Authors' response to the comments of referee #1 on the article

"Domestic wells have high probability of pumping septic tank leachate"

by J.E. Horn and T. Harter

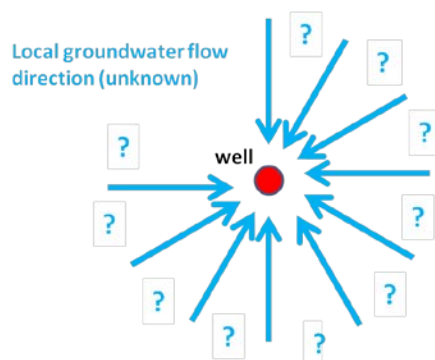
RC: “c. Figure 1: If the authors are not showing the capture zone here, what is the point of showing details on capture zone? Makes the figure confusing.”

RC: “d. Figures 1 and 2 would benefit if the main capture zone and the elongated capture zones can be shown”

AC: The well capture zone is already shown in Figure 1. Figure 1 shows the principal, conceptual set-up of the spatial analysis: the well and its well capture zone relative to a pattern of individual property lots. The revised Figure 1 will show additional capture zone positions and its rotation as considered in the statistical analysis. The figure labels and caption will be revised to clearly identify what is shown.

AC: Figure 2 shows, in dark, a simplified representation of the well capture zone for purposes of illustrating our approach. To optimize the representation, in section 2, the revised manuscript will provide additional details on the method used to determine the well capture zone. We will also revise labeling and the caption of Figure 2.
